The City of Lake Elmo  
Planning Commission will conduct a meeting on  
**Monday February 25, 2019**  
**at 7:00 p.m.**  
**AGENDA**

1. Pledge of Allegiance
2. Approve Agenda
3. Approve Minutes
  - a. February 11, 2019
4. Public Hearings
  - a. **PRELIMINARY PLAT, EASEMENT VACATIONS AND REZONING.** Pulte Homes of Minnesota is requesting City approval of preliminary plat, easement vacations, and a rezoning to develop a townhouse project called "Bentley Village". This development would be on the south side of 5<sup>th</sup> Street across from Jasmine Road and Junco Road in Section 34, Township 29, Range 21 and would have 240 attached townhomes on about a 41.6 acre site for an average density of 5.77 units per acre.

**City of Lake Elmo  
Planning Commission Meeting  
Minutes of February 11, 2019**

PROJECT:  
**FOUR CORNERS 2ND ADDITION**  
HUDSON BOULEVARD REALIGNMENT  
AND TRUNK UTILITY EXTENSION  
LAKE ELMO, MN

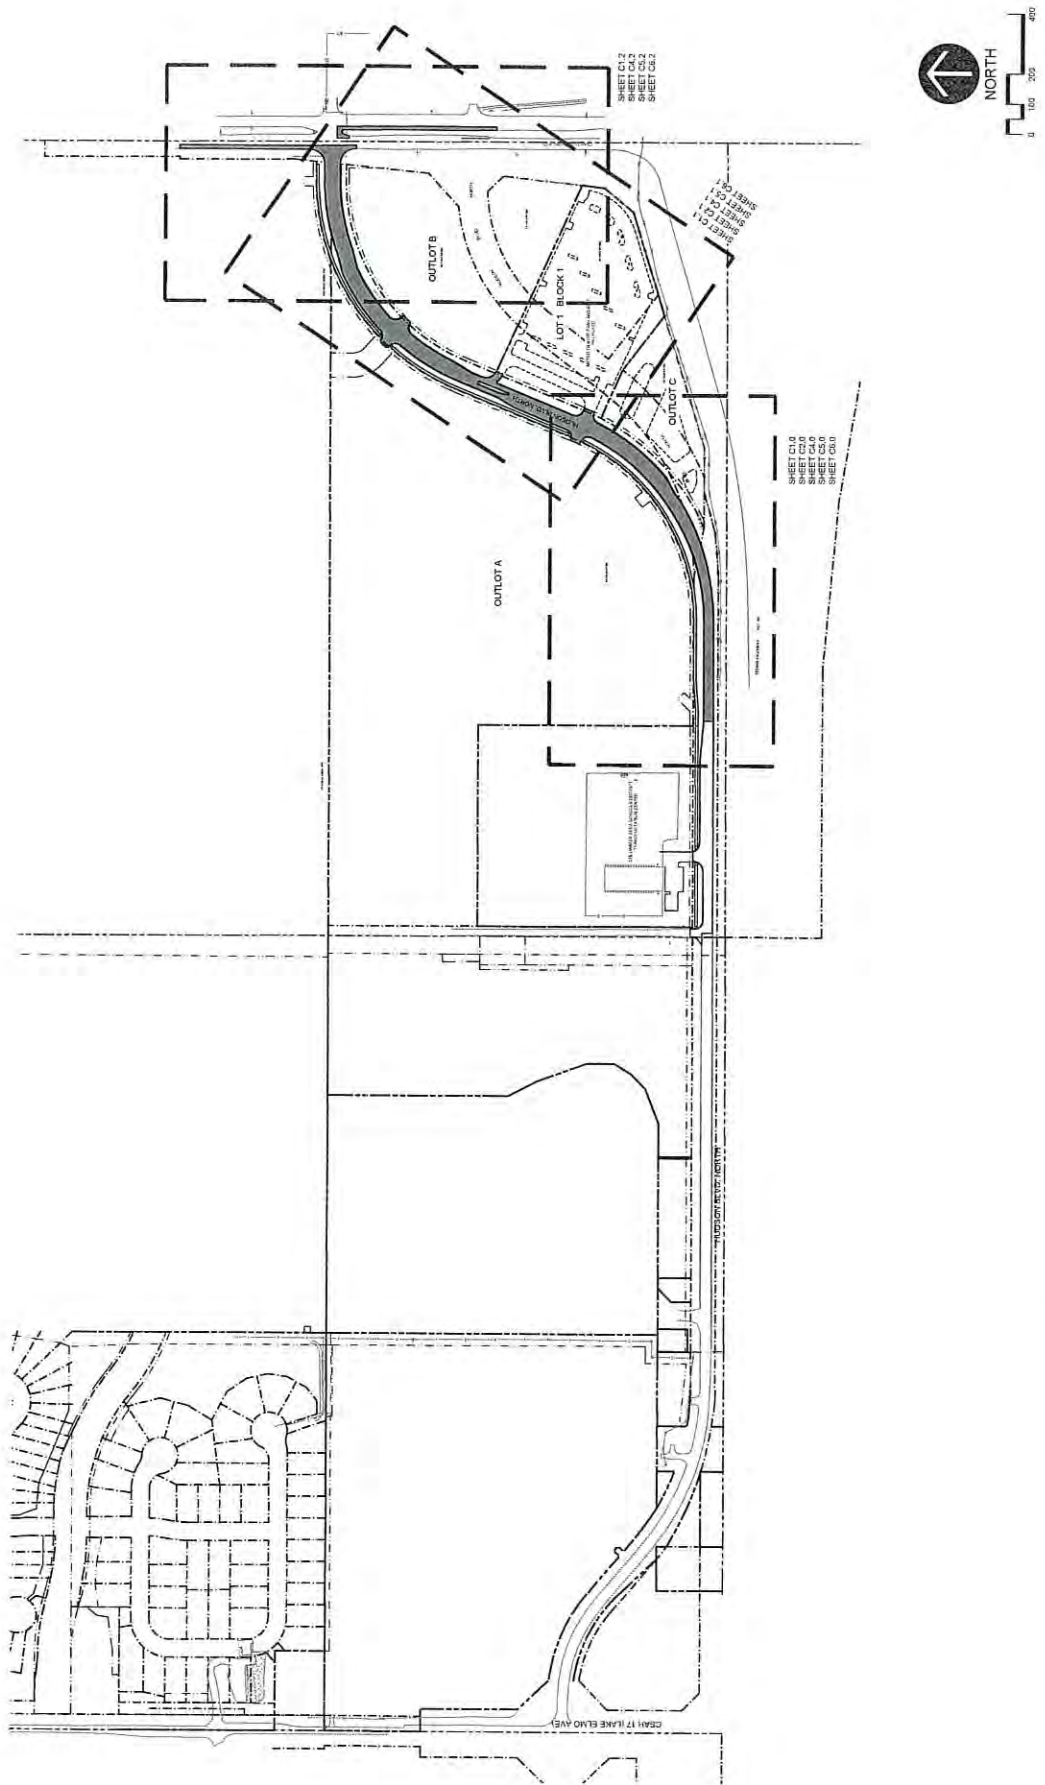
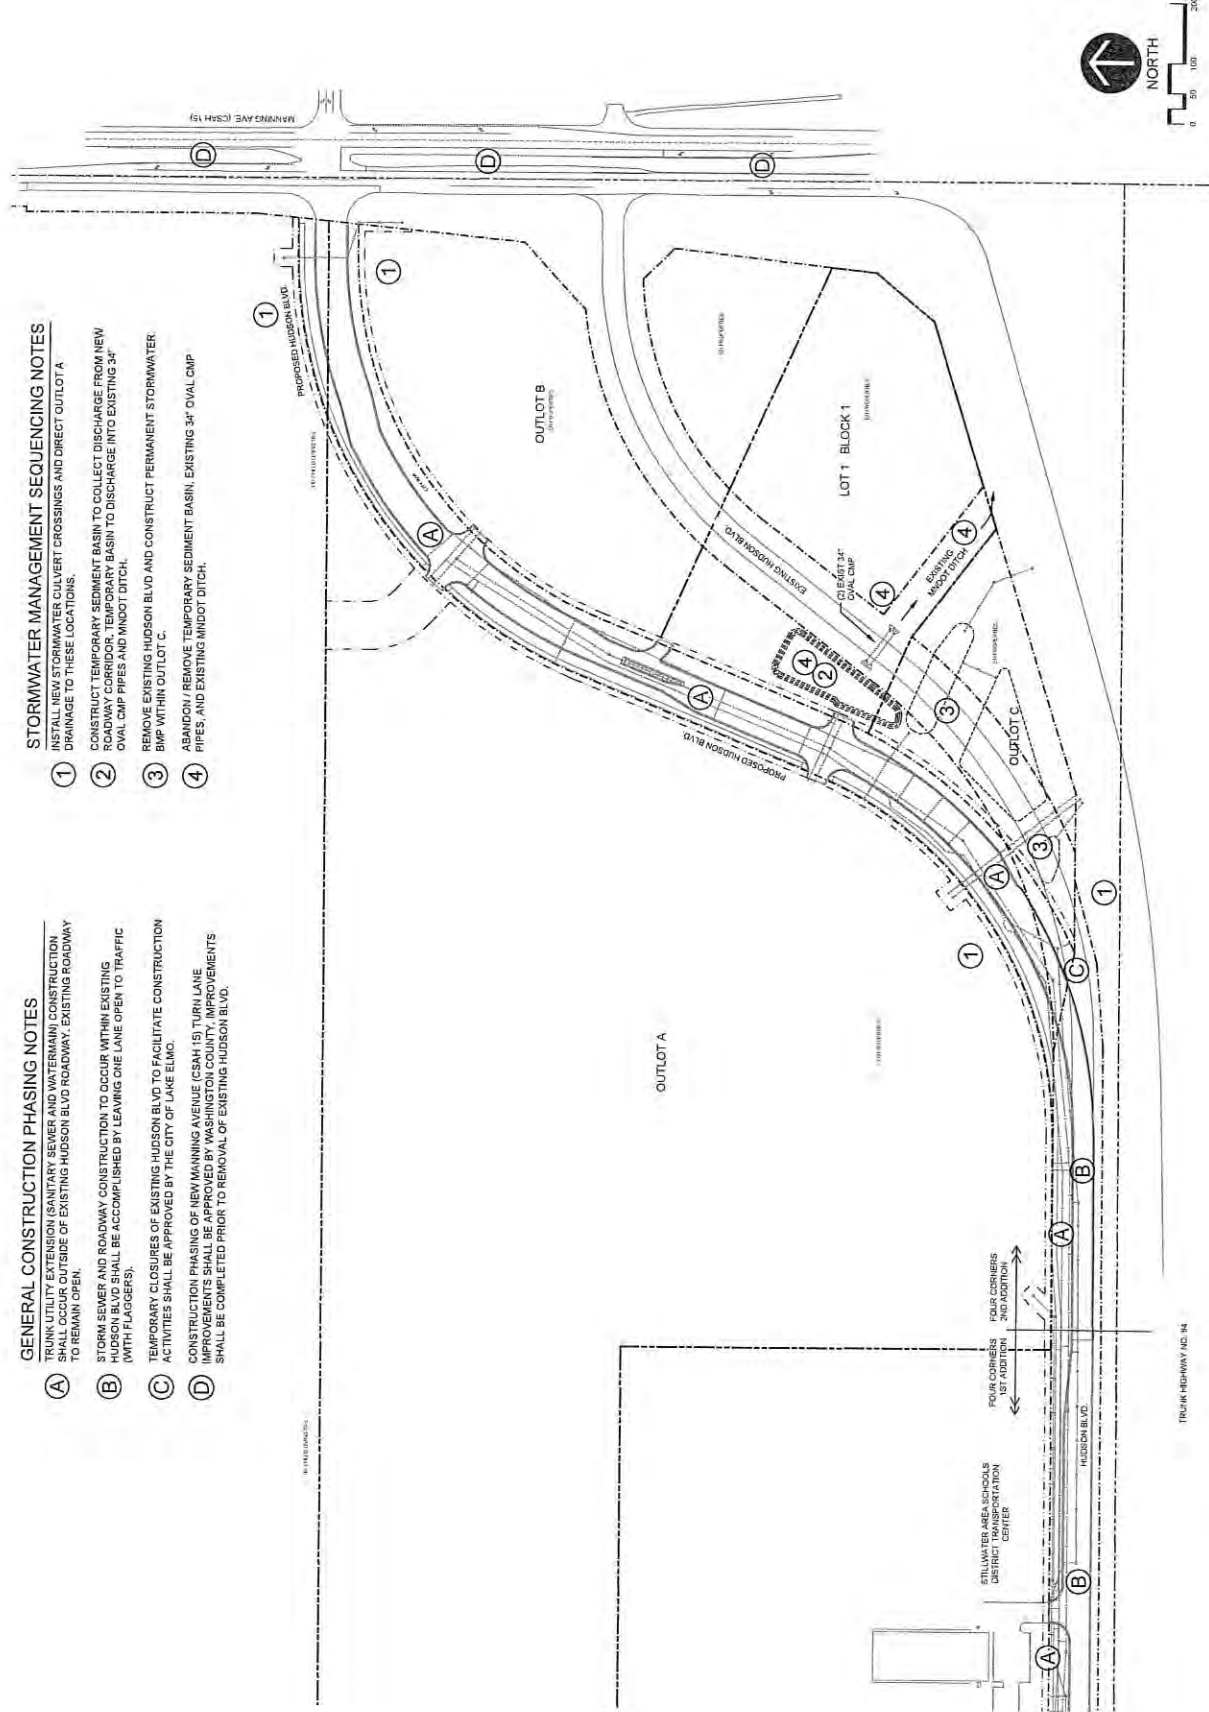
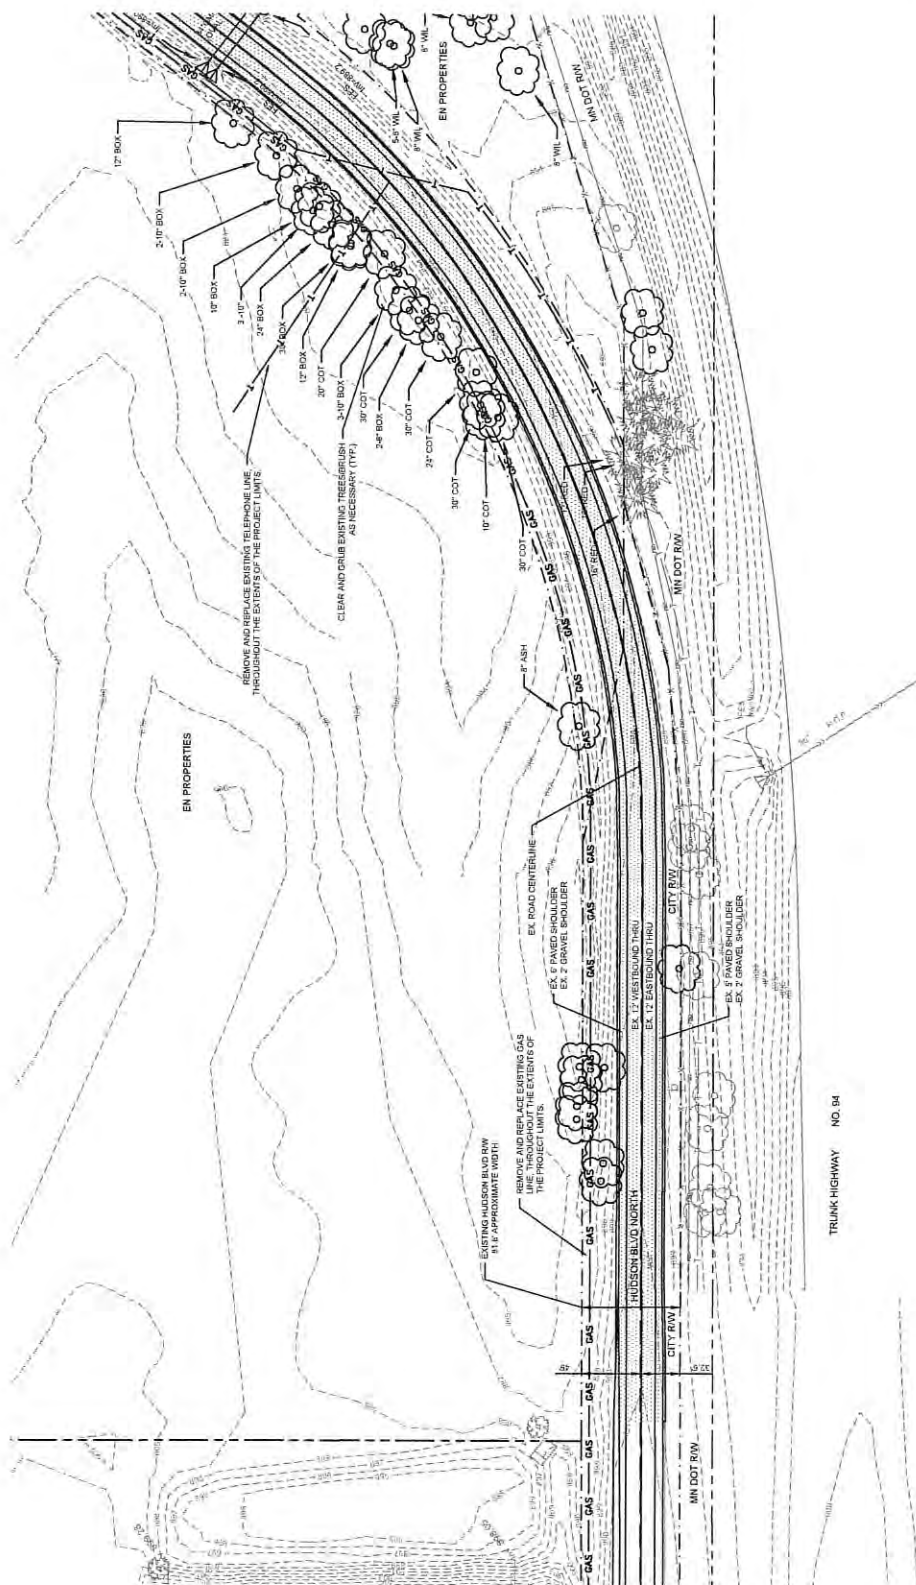
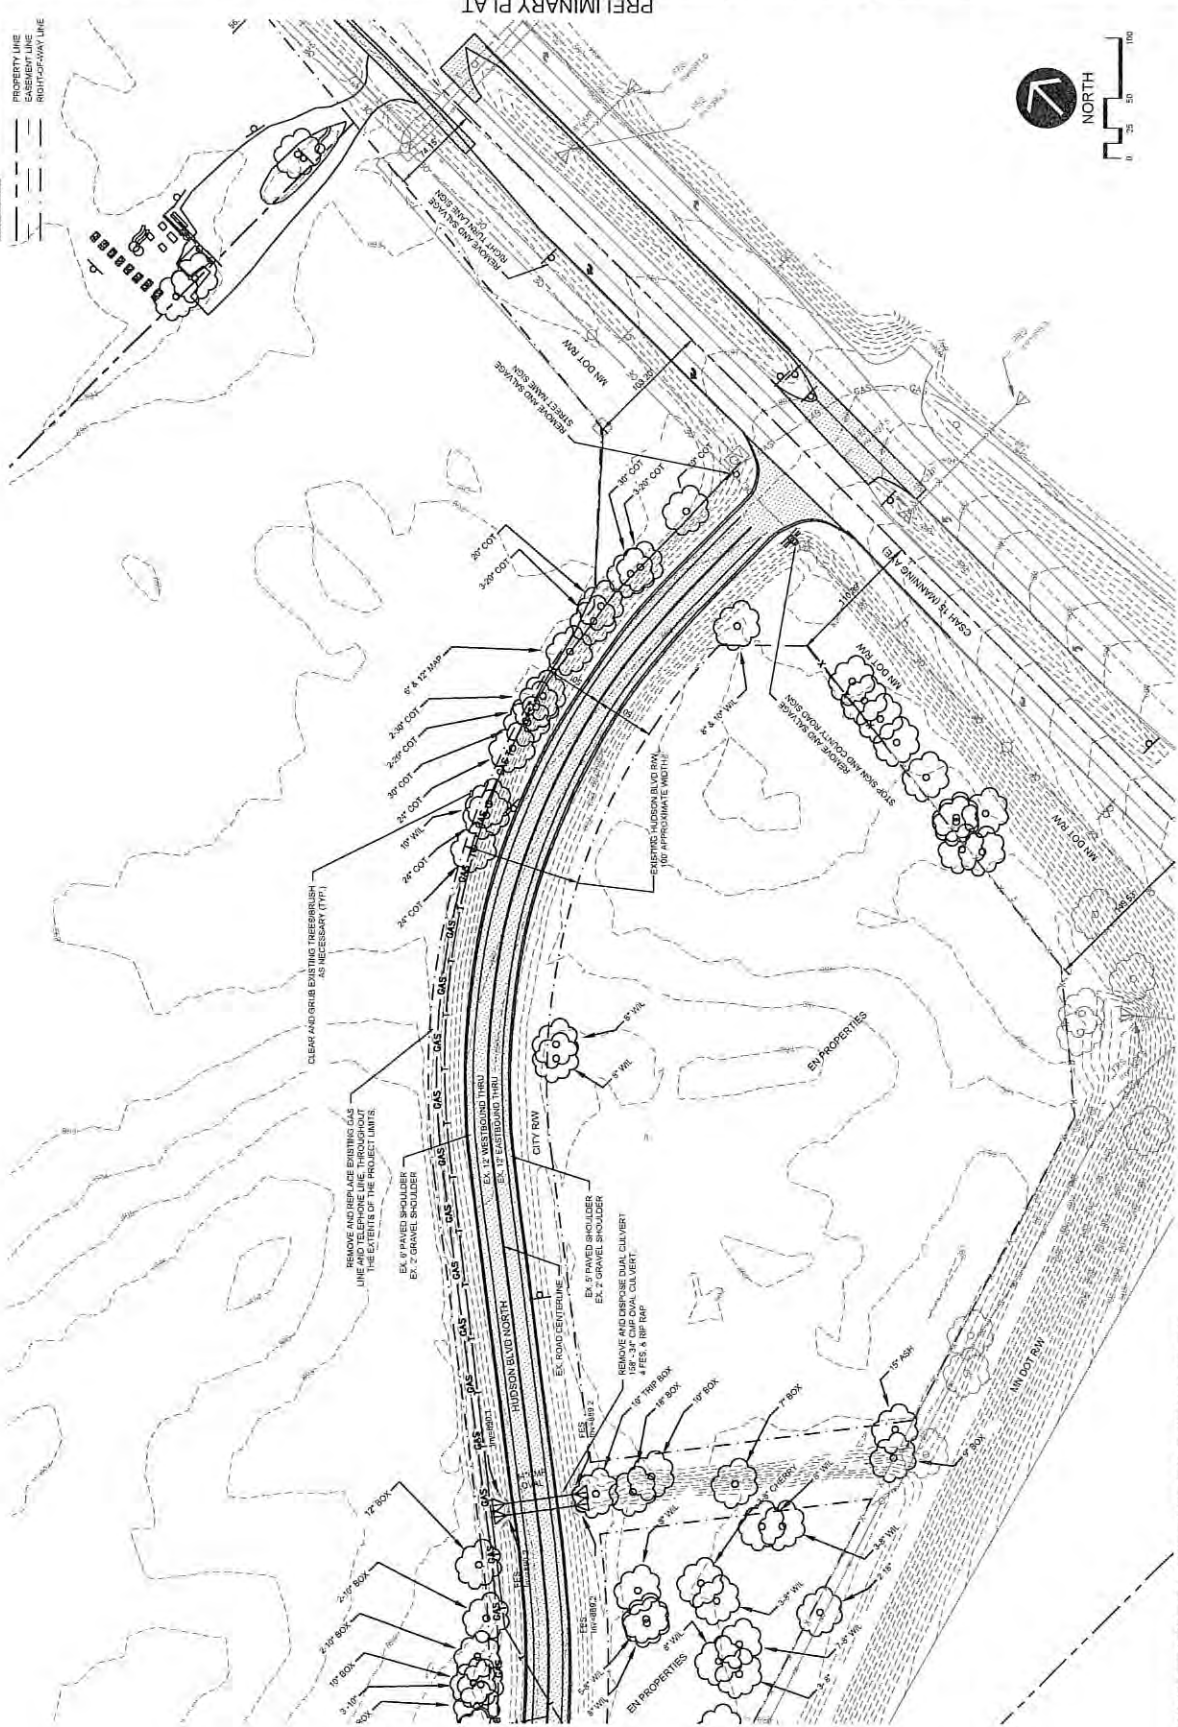
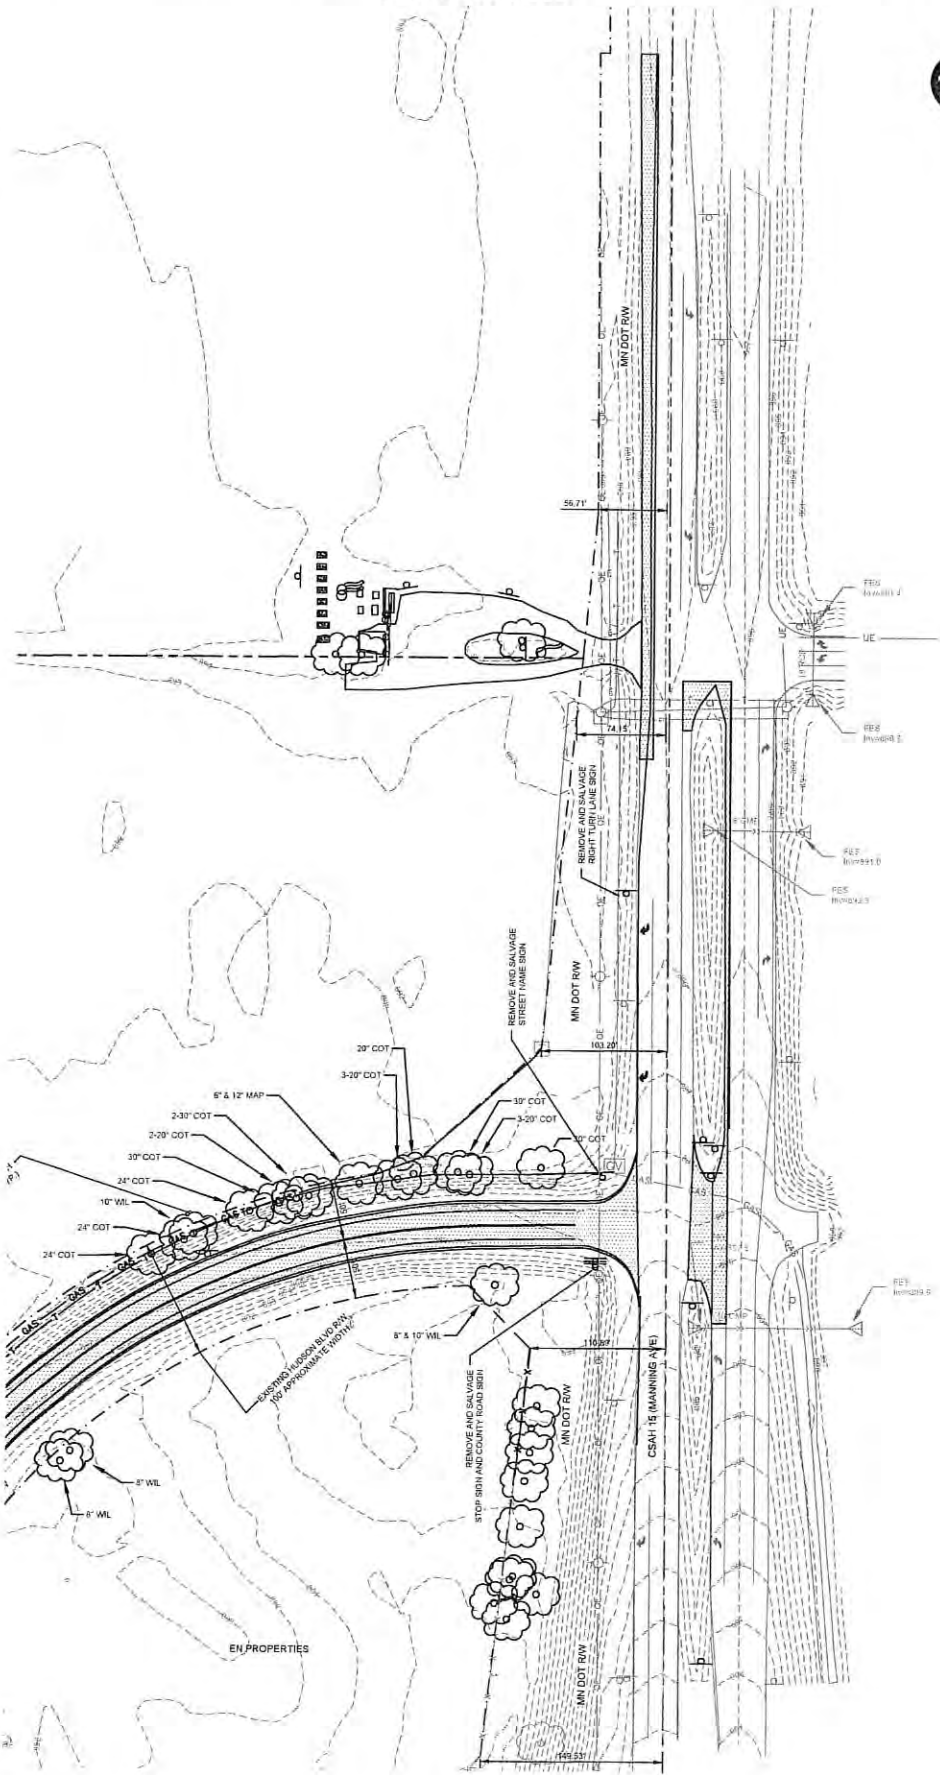
- C0.1. Construction Phasing. The Preliminary Plans must be revised to better detail the construction phasing between street construction and storm water management.

- C2.0. Realign water/sewer per attached exhibit.
- C2.0 -C2.1. Revise the sanitary sewer and watermain stub pipe sizes to 24-inch sanitary sewer and 12-inch watermain at STA 26+00, extending to the northwest.

- C3.0. Revise the street widths to 40 feet for both westerly street stubs.
- C4.0. Label all FES structures. Add storm sewer chart to the plans with pipe cover and pipe velocities.

- C4.0. Extend the storm sewer pipe stub from STMH18 to 15 feet from the bituminous trail to avoid trail excavation during future extension of pipe.
- C4.0. Revise STMH18 to a catch basin to eliminate the manhole in the drive lane.

- C4.2. Add sight triangles at the intersection with Manning Avenue as required by Washington County.
- C4.3. Revise Typical Sections as follows:
  - Locate trail 2-feet from right-of-way.

- Revise paved rural section shoulder from 5-feet to 6-feet.
  - Remove pavement section details for the bituminous trail and add note "see City Standard Detail 509".

- Add 10-foot utility easement on south side for typical section from 11+50 to 14+88.
- C4.4. Revise Typical Sections to add note for trail pavement section to "see City Standard Detail 509".

- C5.0-C5.2. Add street stationing to the signing and pavement marking plans.
- C5.0-C5.2. Add dimensions and notes for the location and placement of all pavement markings.

- C5.0. Add City standard plan notes for signing and pavement markings.
- C5.0. Revise sign schedule to identify MUTCD sign codes and sign sizes.
- C5.1. Add Type III barricades (2 each) at the end of both stub streets and update sign schedule.

- C6.0. Minimum standard ditch grade is 2% for positive drainage. Revise the drainage ditch grading along the north boulevard to eliminate flat areas and standing water.

- C6.0. Add drainage easements for the proposed drainage ditch on the north side of Hudson Boulevard.
- C6.0. Additional borings are required for each infiltration basin. A minimum of 2 borings are required per basin and must be obtained from within the actual proposed basin location. Additional borings are required for basins larger than 10,000 square feet (see engineering design standards manual).

- C7.0. Revise vertical curve at STA 31+47. The City standard minimum K-value for 45 mph sag curve is 79.
